**AGENDA**  
**CITY OF LAKE WORTH BEACH**  
**HISTORIC RESOURCES PRESERVATION BOARD REGULAR MEETING**  
**CITY HALL COMMISSION CHAMBER**  
**WEDNESDAY, OCTOBER 13, 2021 -- 6:00 PM**

**RE:** **320 North Lakeside Drive | Continuance**

**TITLE: HRPB Project Number 21-00100222:** Consideration of a Certificate of Appropriateness (COA) for the construction of a new +/- 1,790 square foot addition for the single-family residence at 320 North Lakeside Drive; PCN #38-43-44-21-15-430-0050. The subject property is located within the Single-Family Residential (SF-R) zoning district and is a contributing resource to the Old Lucerne Local Historic District.

**Existing Window and Door Replacement**  
 South Elevation

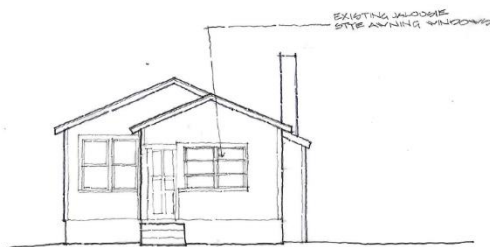
- South Elevation:
  - Removal of three window openings to be replaced with faux shuttered openings

**Existing Window and Door Replacement**  
 East Elevation

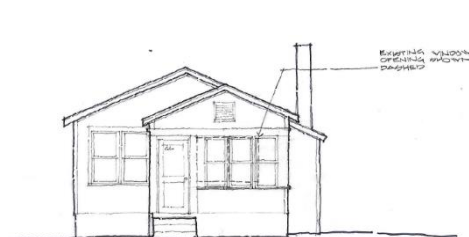
- East Elevation:
  - Alteration of a paired window opening to accommodate a triplet of windows

The enclosed front porch currently utilizes replacement jalousie windows. The proposal will replace these windows with pairs of single-hung windows that are compatible with the Wood Frame Vernacular architectural style, according to the City’s Historic Preservation Design Guidelines. The enclosed rear porch also utilizes replacement windows. An existing pair of awning windows will be replaced with a tripled of single-hung windows.
